EXHIBIT 3 - STAFF REPORT

DATE: September 20, 2023
TO: Landscape Review Committee Members
FROM: Adam Tate, Associate Planner
SUBJECT: Landscape Plan Review Application (L 31-23)

DECISION, CONDITIONS, FINDINGS OF FACT AND CONCLUSIONARY FINDINGS FOR THE APPROVAL OF A LANDSCAPE PLAN REVIEW FOR PARALELL VENTURES, LLC ON PROPERTY AT 2675 NE ORCHARD AVENUE, TAX LOT R4415-02700

DOCKET: L 31-23 (Landscape Plan Review)

PLANTING PLAN

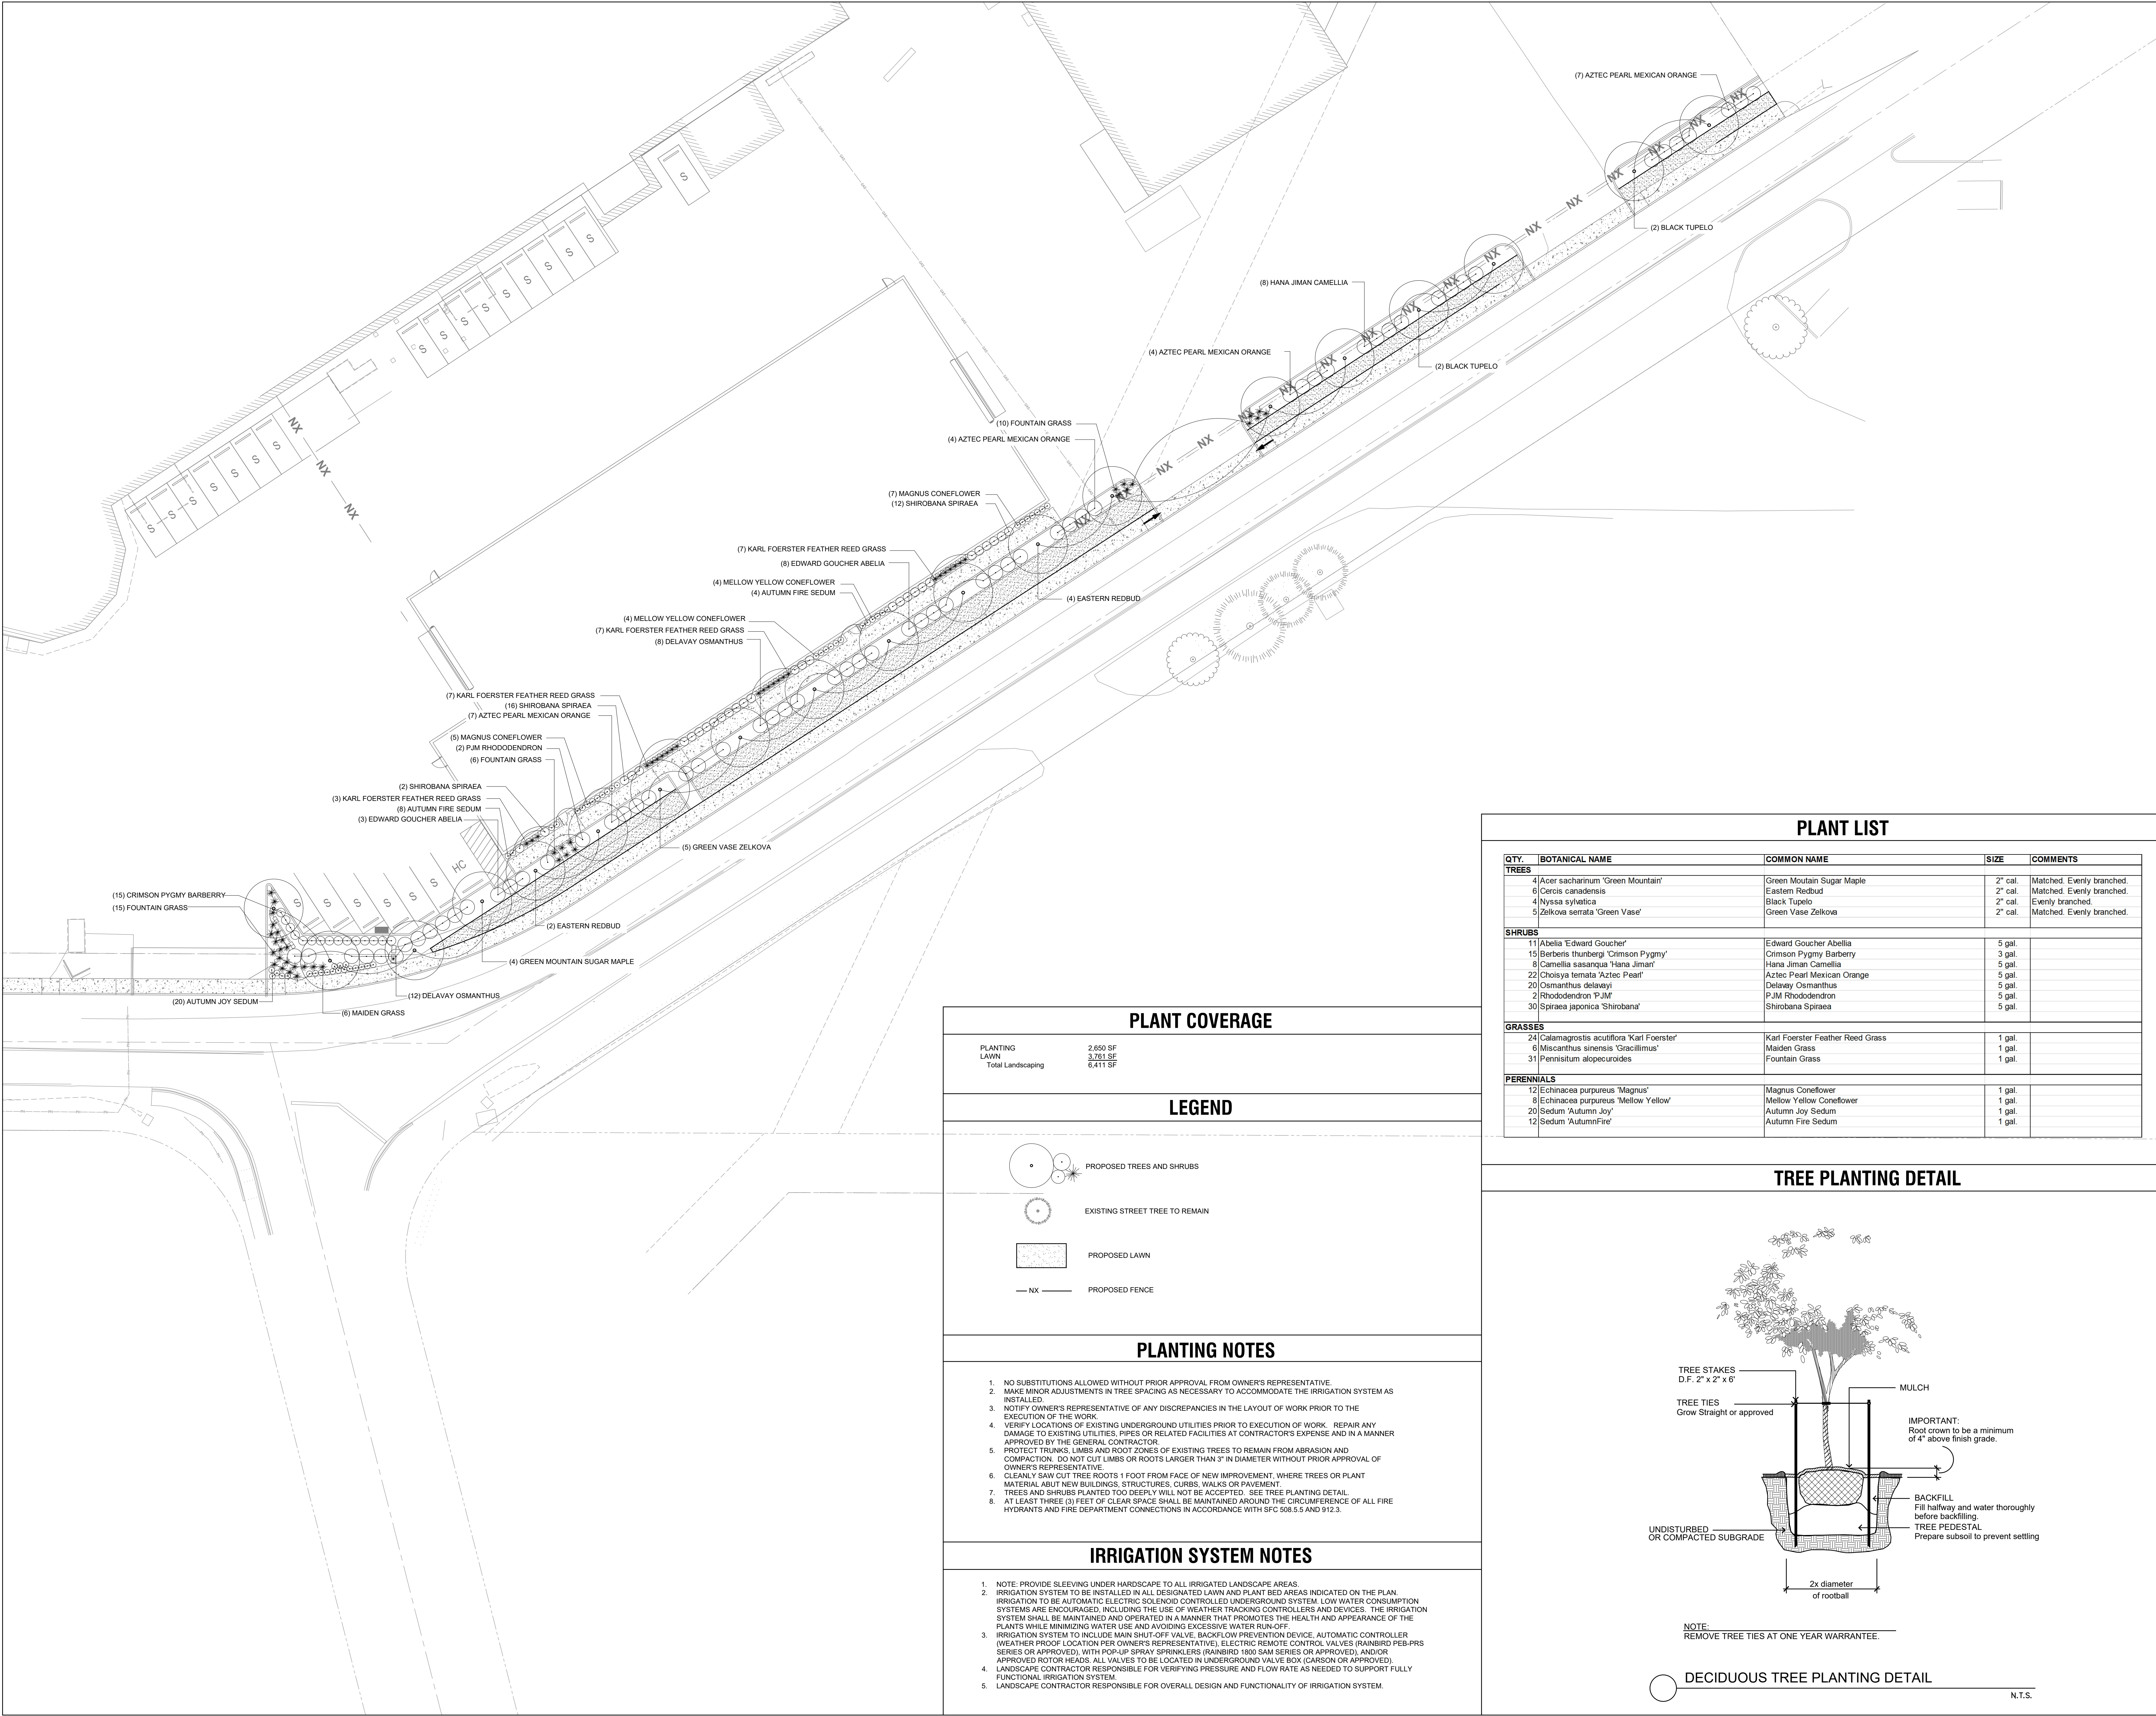
From the submitted drawing it appears to me that the proposal calls for trees on private property, outside of the right of way. It appears that the only landscaping proposed in the right of way is turf, extending from the back of walk to the property line. Typically, street trees are planted in the right of way.

Our comment would simply be to inquire about this approach and to have applicant describe why that approach was taken. It may well be that there is an underground conflict that is not shown on the plans that would preclude planting trees.
